**PROPOSED RESIDENTIAL DEVELOPMENT
PARK WEST AVENUE, CHERRY ORCHARD,
DUBLIN 10**

Stage 1 Quality Audit

**(Incorporating a DMURS Street Design Audit, and Audits
of Accessibility, Cycling, Walking and Road Safety)**

Figure 7.1 – Pedestrian Routes adjacent to Sheffield stands

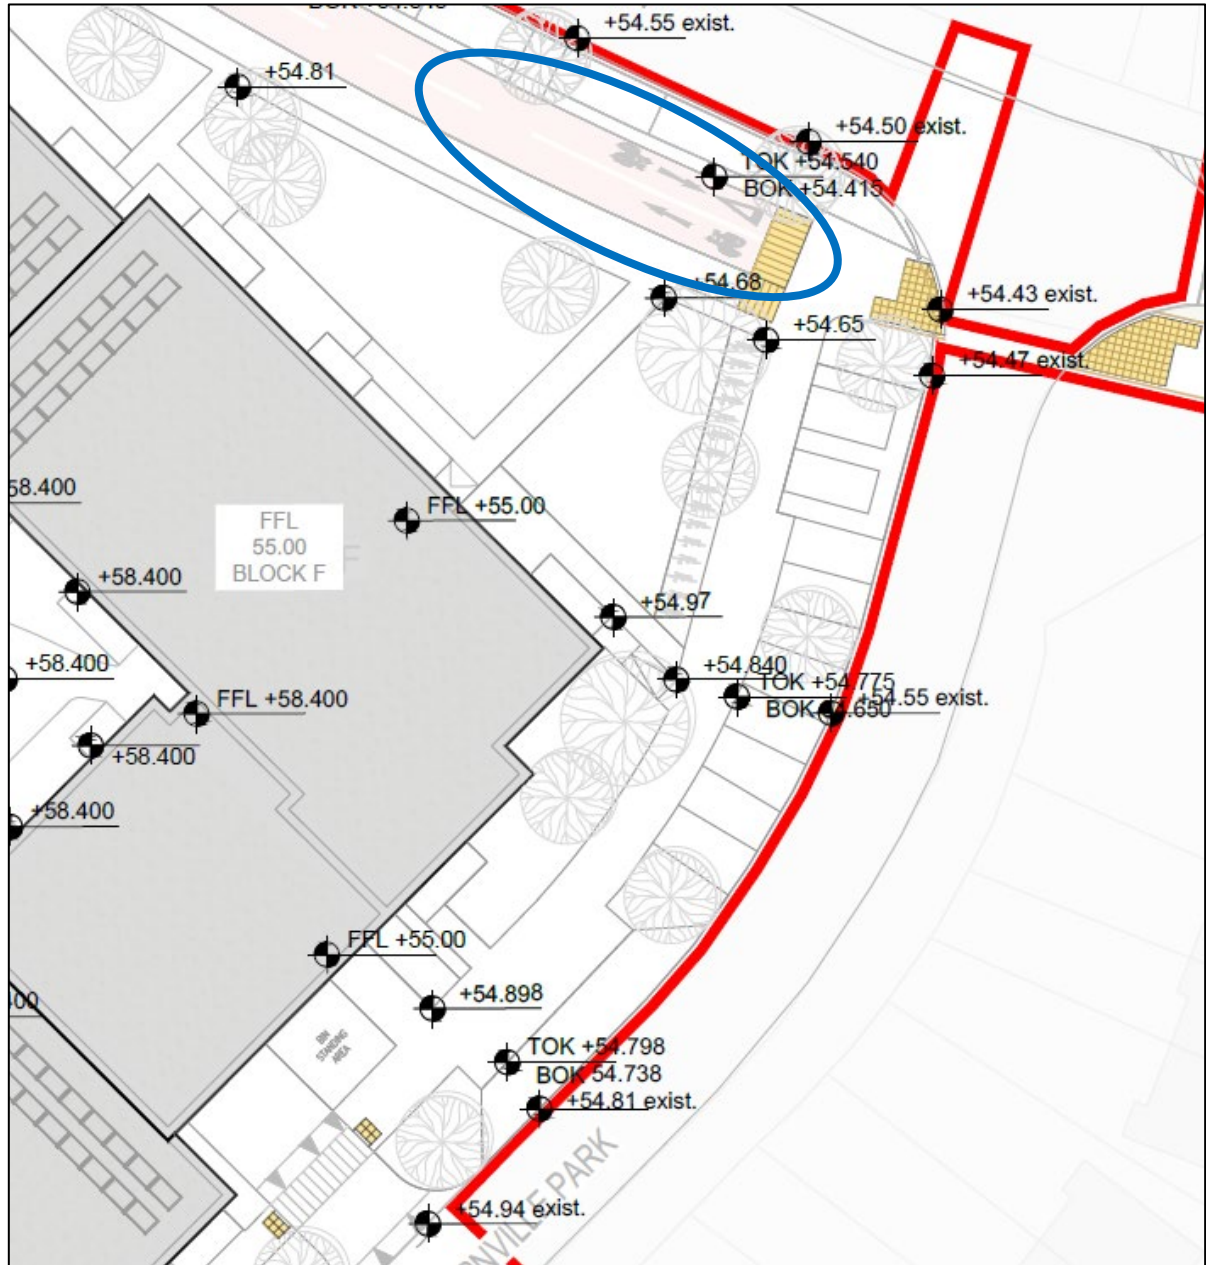
Bi-directional cycleway ends at a congested area including shared space area and pedestrian crossings. It is unclear how cyclists will tie-in to/from this cycleway from surrounding/adjacent cycling routes or desire lines.

Ensure infrastructure provides ample opportunity for tie-in to adjacent/future infrastructure.

7.1	YES	PARTIALLY	Appropriate tactile paving is incorporated into the design to indicate to cyclists that the cycle track terminates at this shared-surface location. Future cycle lane facilities are proposed as part of a separate development to the north of Cherry Orchard Green, with cyclists required to cross the street to access and connect with the future cycle lane.

Figure 7.2 – Sheffield stands

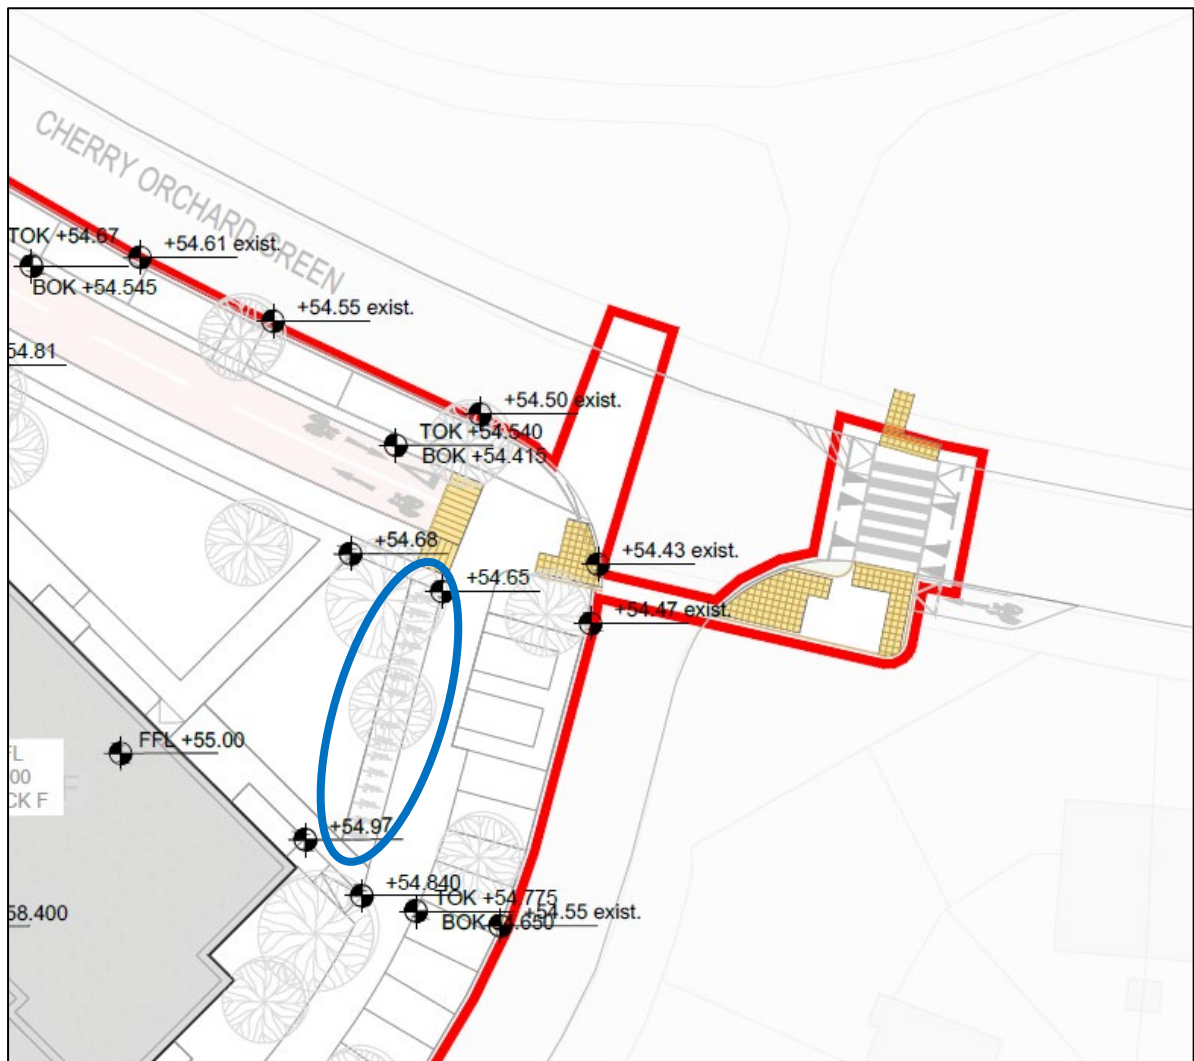
It is unclear how the proposed Sheffield stands will be fixed to the ground. If these are bolted to the ground, where the bolt is accessible, this can give rise to theft by the removal of the Sheffield stand using a socket set (or similar). Risk of theft or non-secure storage may reduce the attractiveness or uptake of the mode.

Ensure secure storage.

Figure 7.3 – Cycle Access

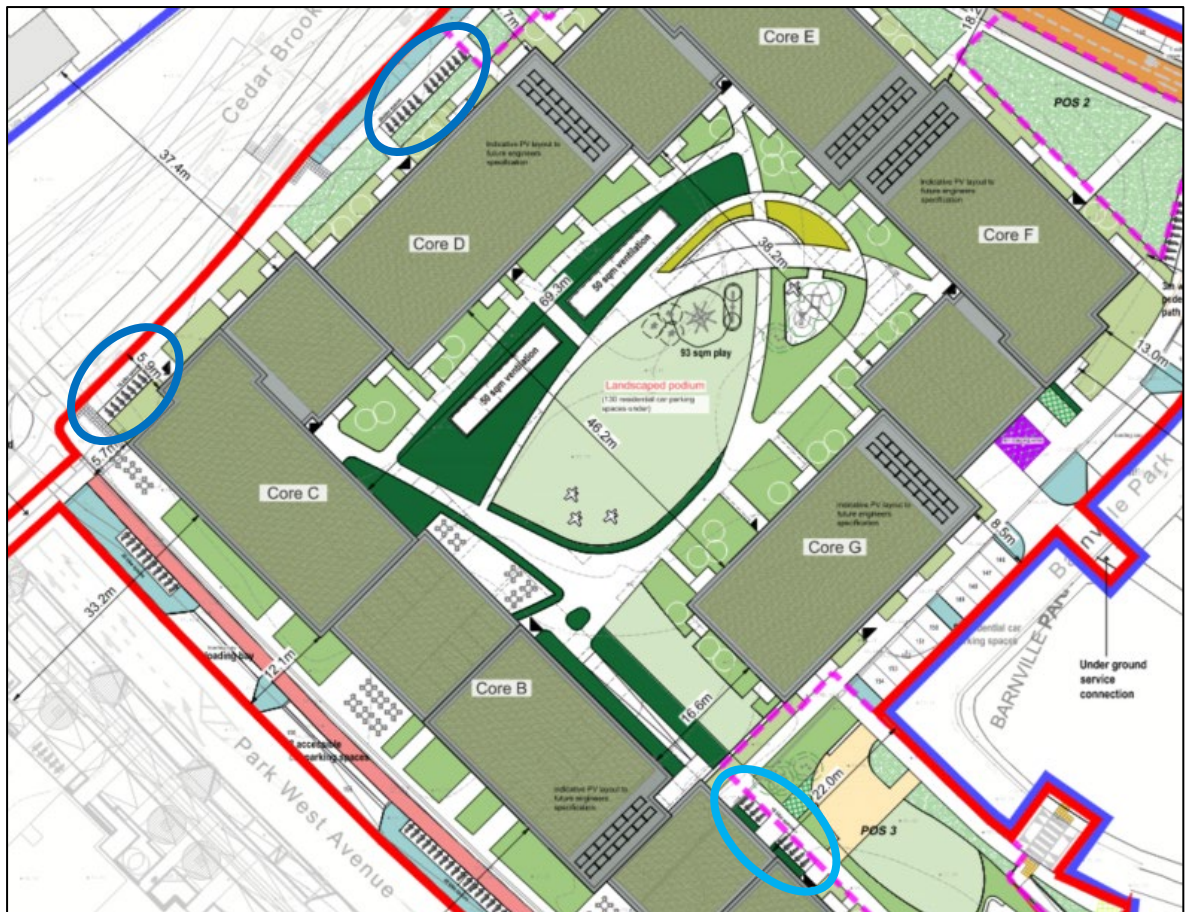
It is unclear how cyclists will access some of the cycle parking areas from the proposed cycle facility. A lack of appropriate connections may lead to conflicts with other road users

Ensure appropriate access is provided from the cycle facility to all the cycle parking areas.

Figure 8.1 – Incorrect Tactile Paving Layout.

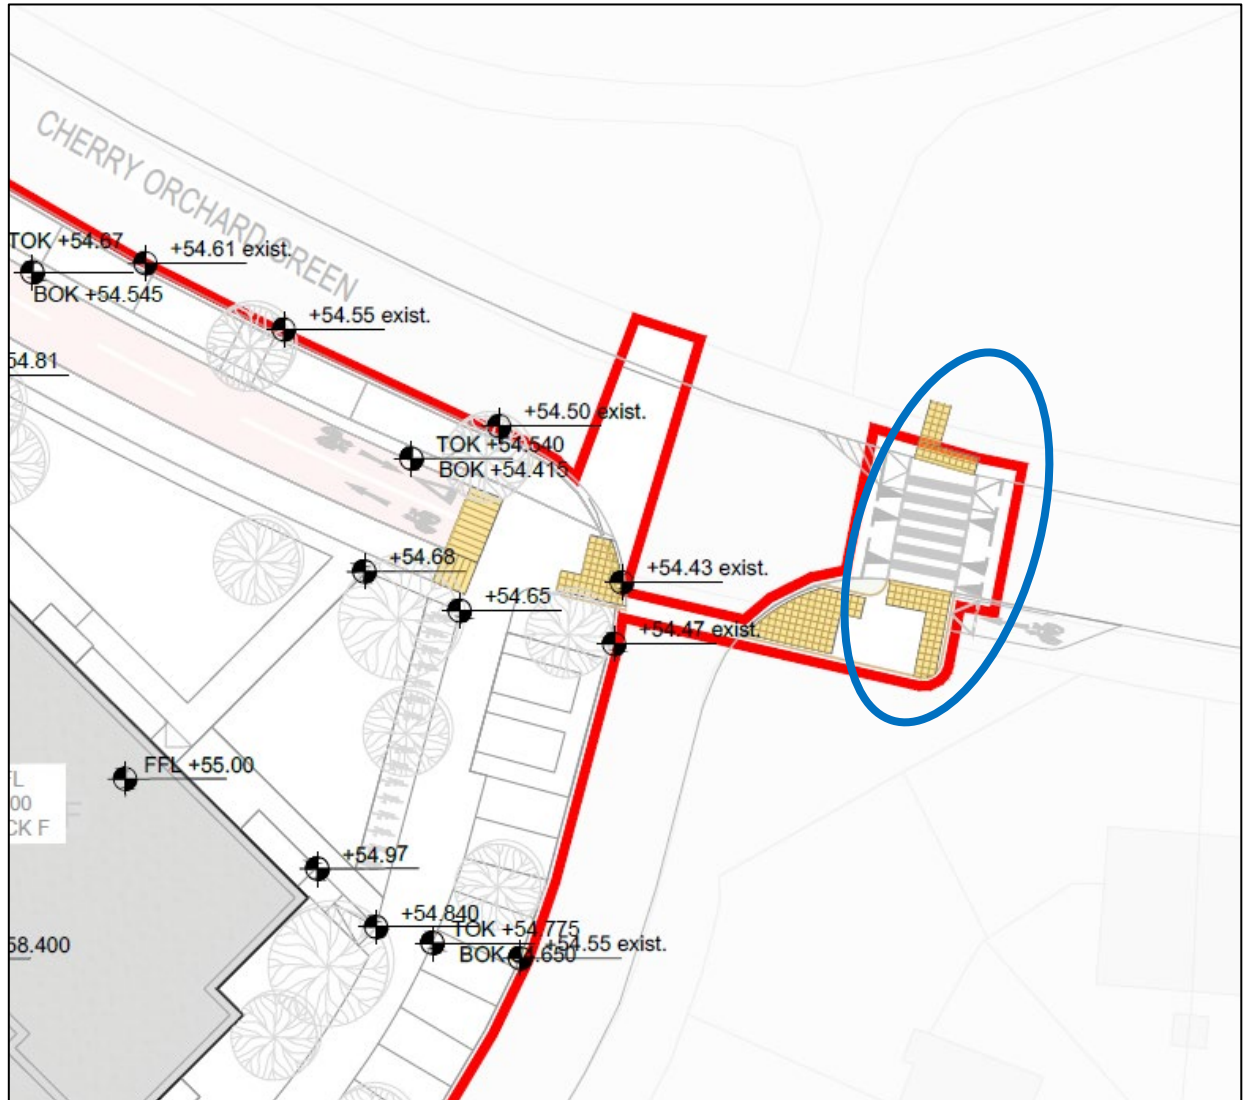
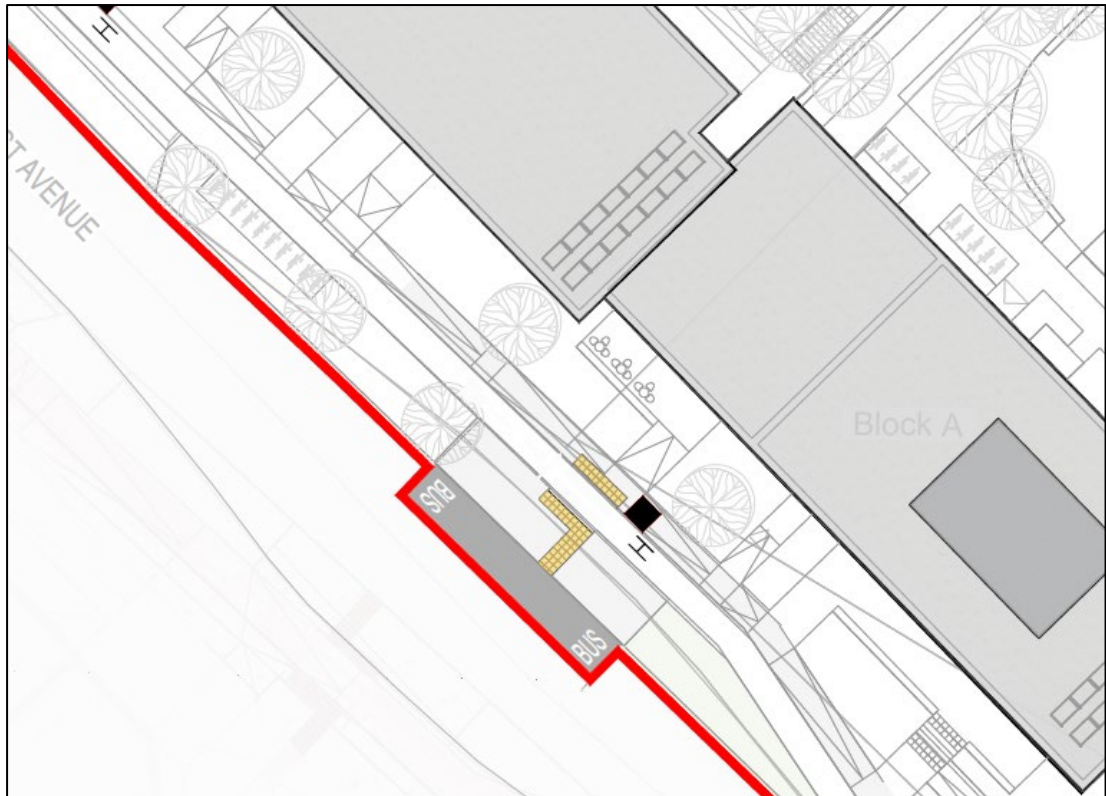
Proposed tactile paving appears to be incorrect (Buff coloured with a tail). Incorrect usage of tactile paving may result in confusion, causing disorientation, for vision impaired users.

Ensure compliance with tactile paving standards to support independent navigation for white cane users.

Figure 8.3 – Footway / Cycleway Arrangement

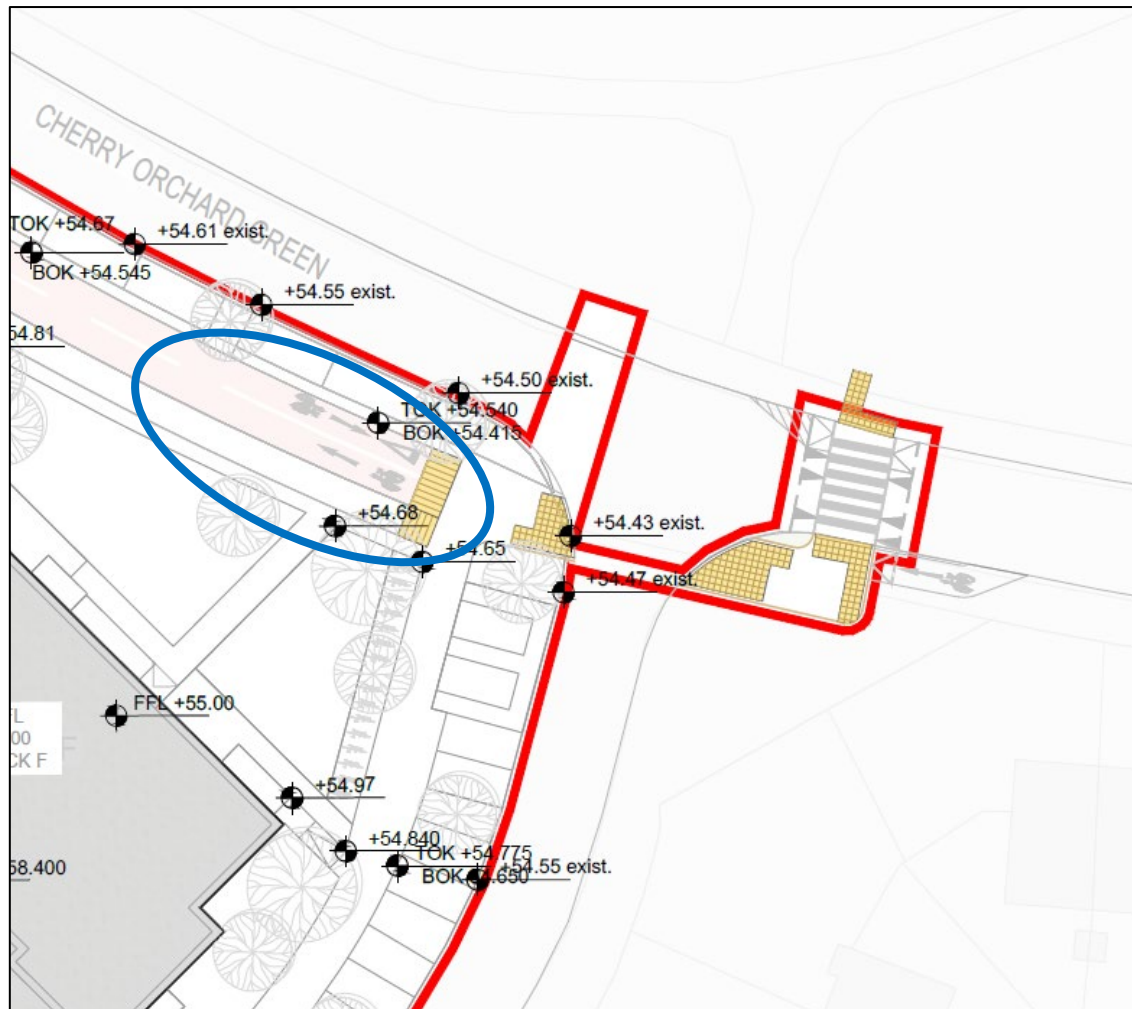
It is unclear if there will be any segregation between the footway and cycleway. Where installed at grade without tactile delineation, this arrangement can cause disorientation for vision impaired users who may walk inadvertently onto adjacent cycleways, creating a conflict.

Consider upstand between footway and cycleway or tactile delineation.

Figure 8.4 – Tactile Paving

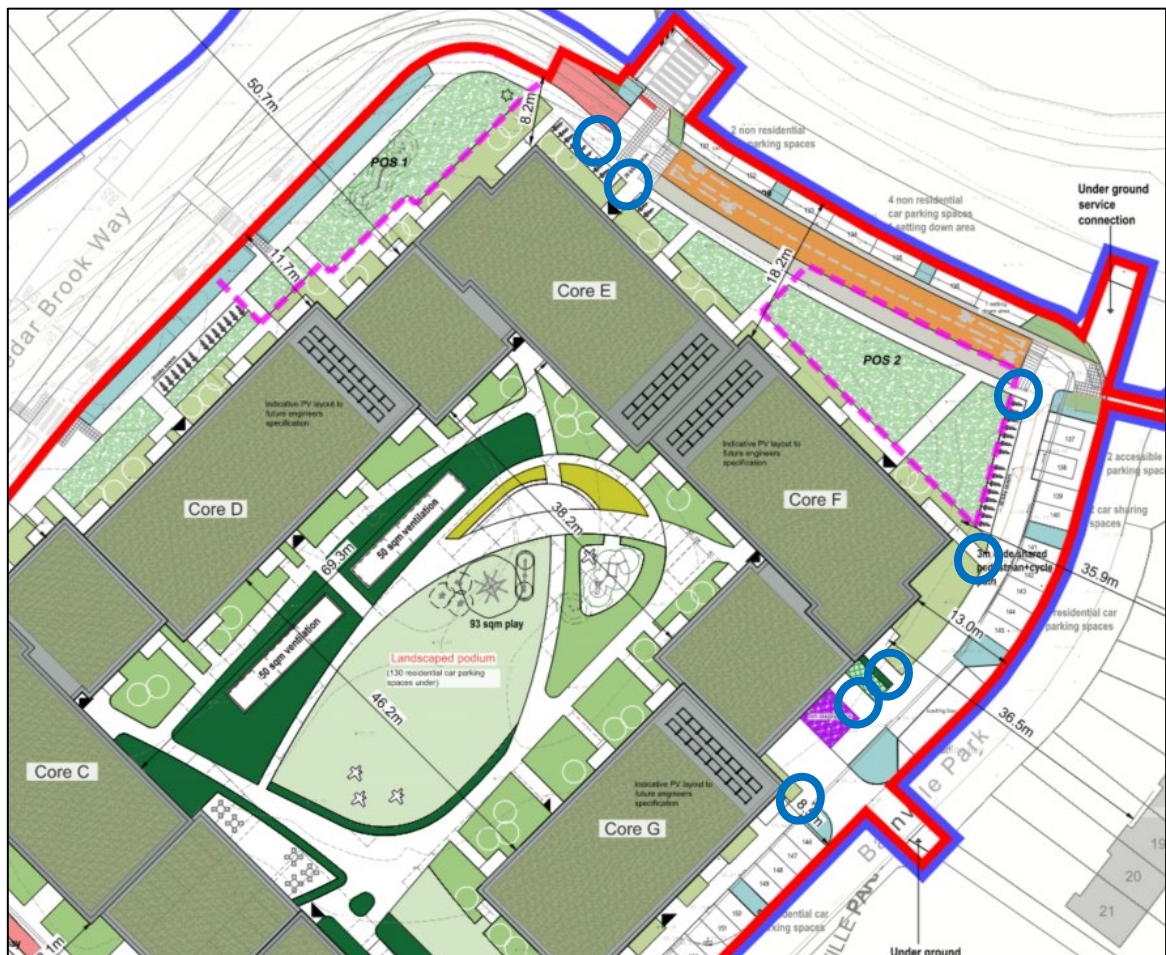
Footpaths intersect with shared pedestrian/cycle facilities at a number of locations throughout the proposed development. However, no measures are indicated to warn pedestrians that they are entering an area where cyclists may be present. The absence of appropriate warning measures may result in pedestrians inadvertently entering the path of cyclists, leading to uncertainty and increasing the risk of collisions between cyclists and pedestrians, particularly vulnerable users such as children, older people, and those with visual impairments.

Provide appropriate tactile paving at locations where footpaths intersect with shared pedestrian/cycle facilities to alert pedestrians to the potential presence of cyclists.
